## TRI-PARTY AGREEMENT

Change Notice Number TPA-CN- 0761	TPA CHANGE NOTICE FORM	Date: 11/17/2016
--------------------------------------	------------------------	---------------------

Document Number, Title, and Revision: DOE/RL-2016-13, Waste Management Plan for the 200-UP-1 Groundwater Operable Unit, Rev. 0	Date Document Last Issued: January 2016
---	--

Figure 1. 200-UP-1 Waste Storage Location

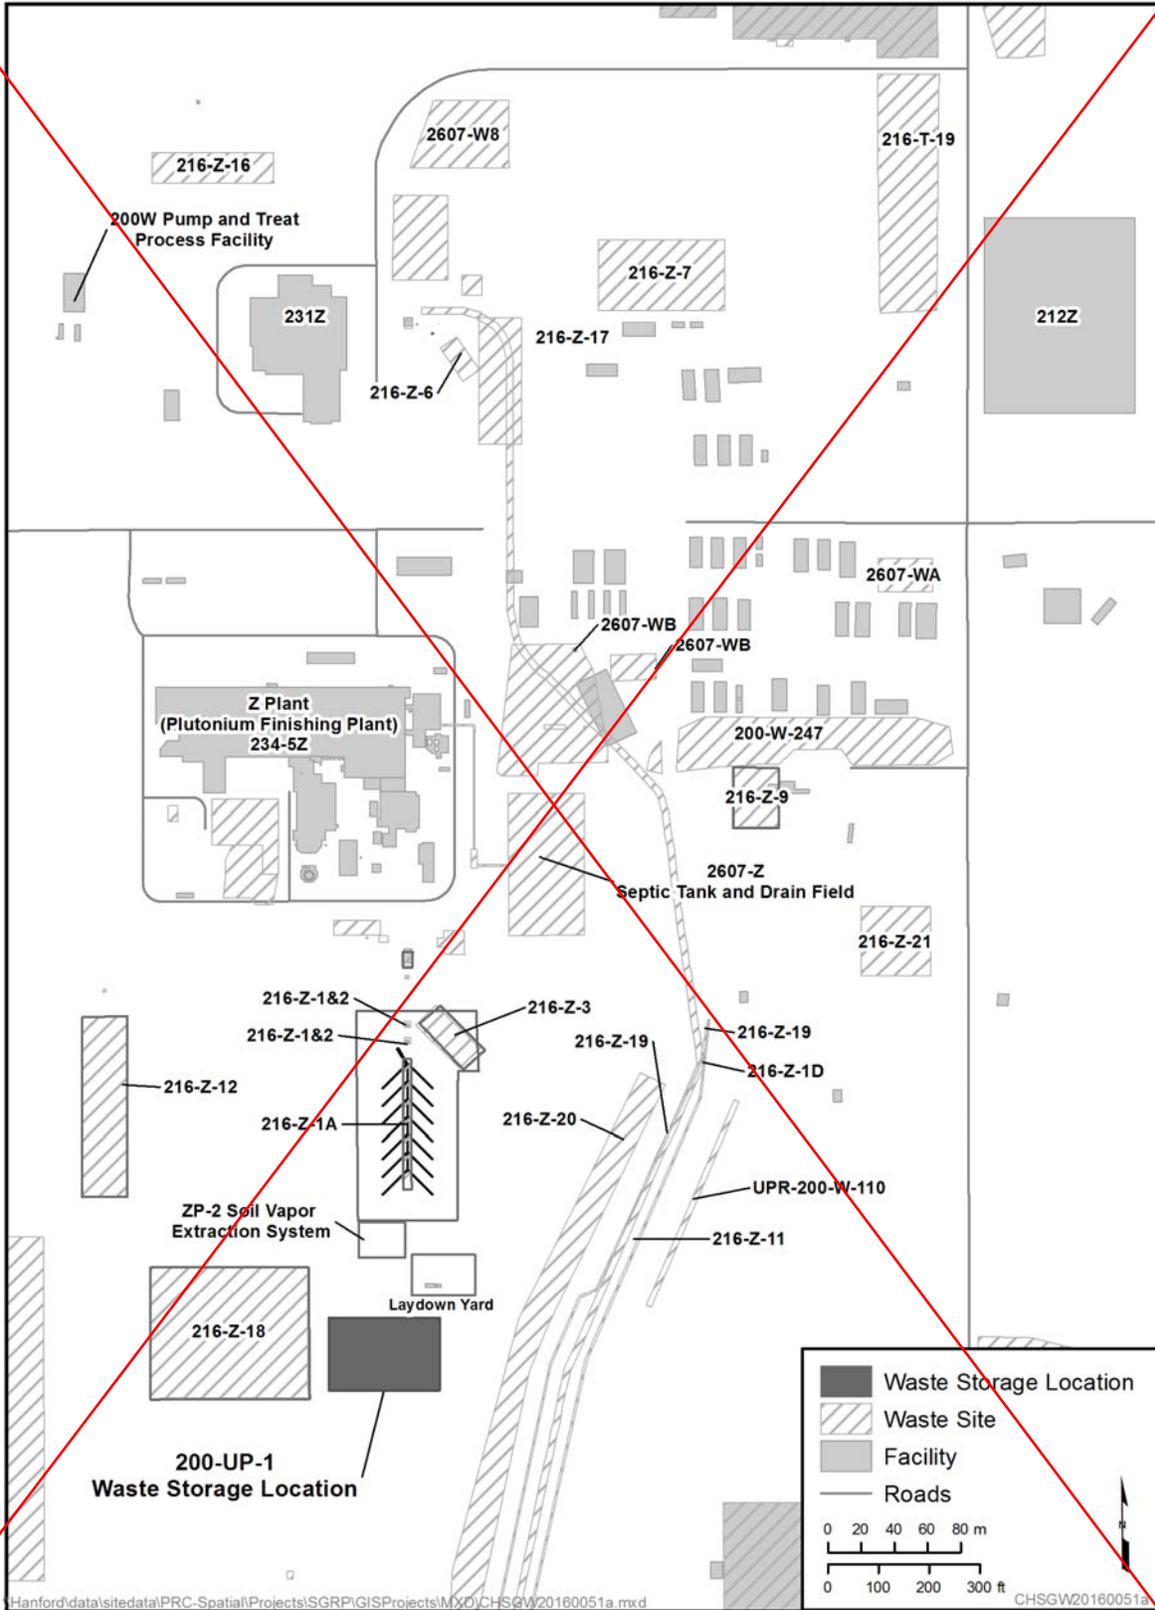
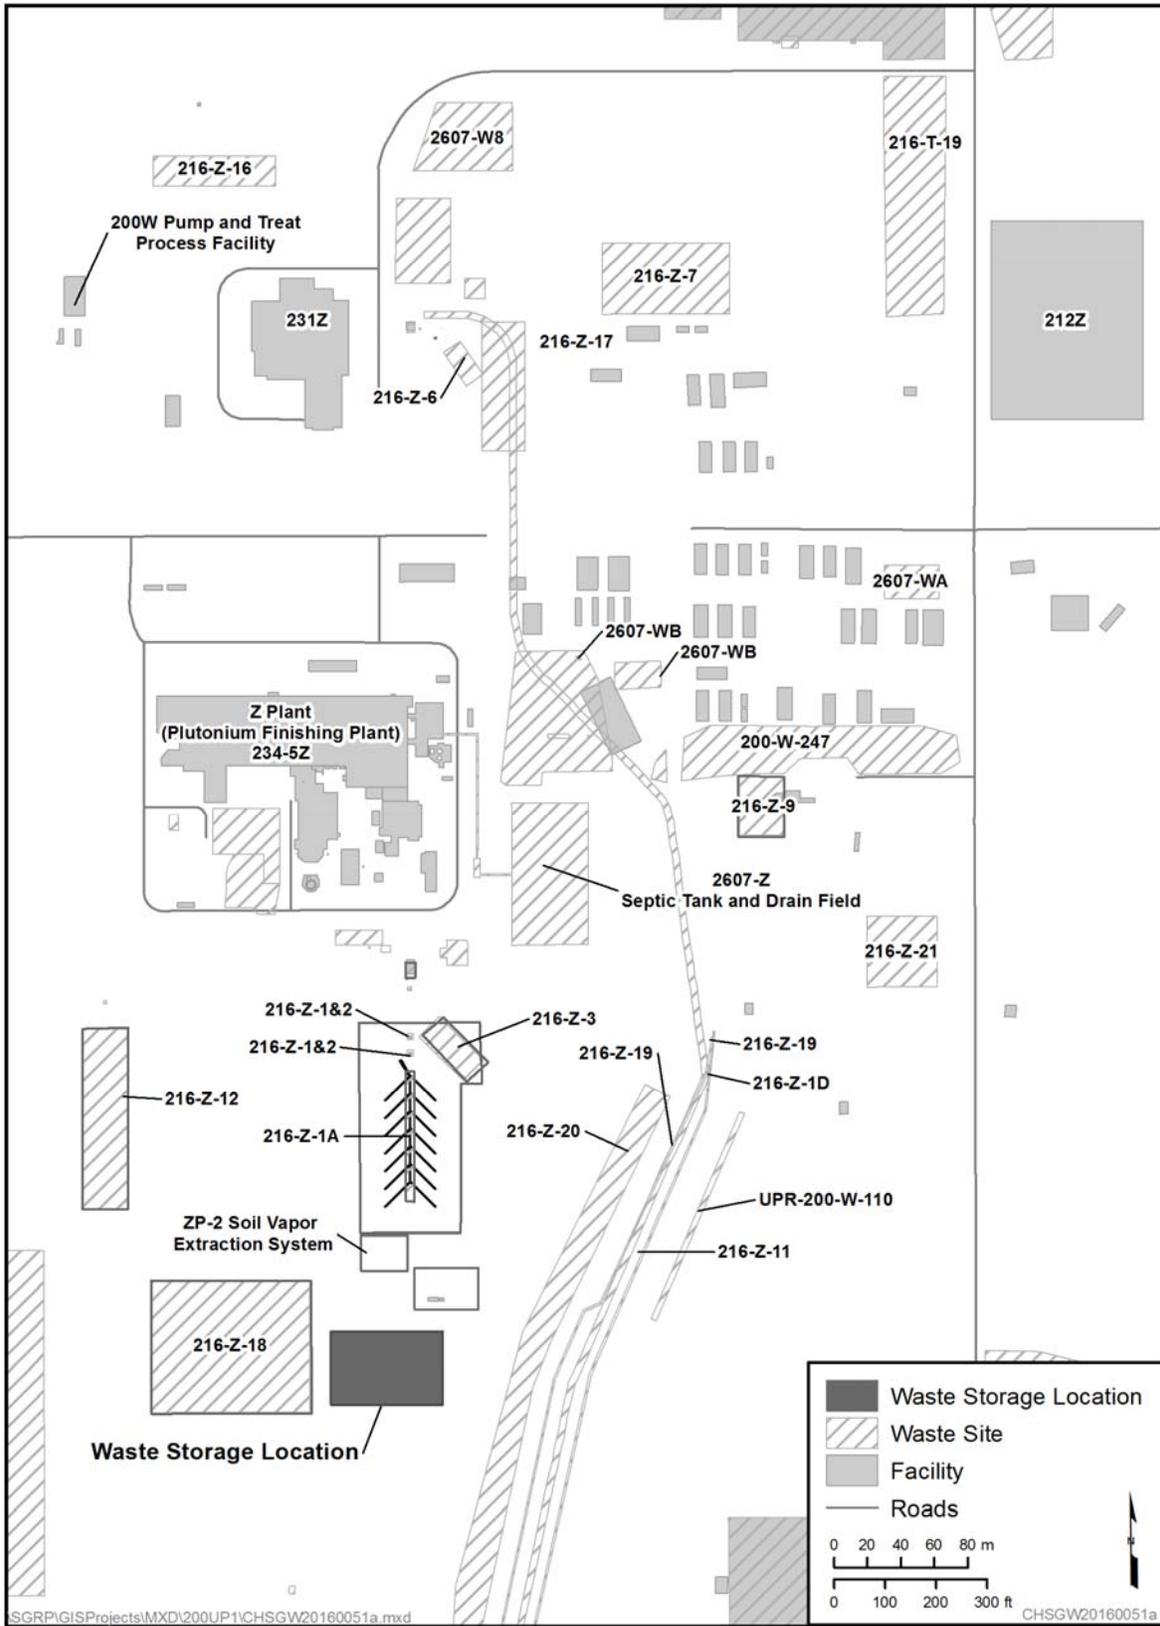
**Description of Change:**  
 Edit the description of the location of the waste storage area in Figure 1, "200-UP-1 Waste Storage Location," of DOE/RL-2016-13, *Waste Management Plan for the 200-UP-1 Groundwater Operable Unit*, Rev. 0.

Figure 1, "200-UP-1 Waste Storage Location," of DOE/RL-2016-13, *Waste Management Plan for the 200-UP-1 Groundwater Operable Unit*, Rev. 0, was updated.

**Justification and Impacts of Change:**  
 Text in Figure 1, "200-UP-1 Waste Storage Location" is being edited to match that of Figure B-4 of DOE/RL-2009-124, *200 West Pump and Treat Operations and Maintenance Plan*, Rev. 5.
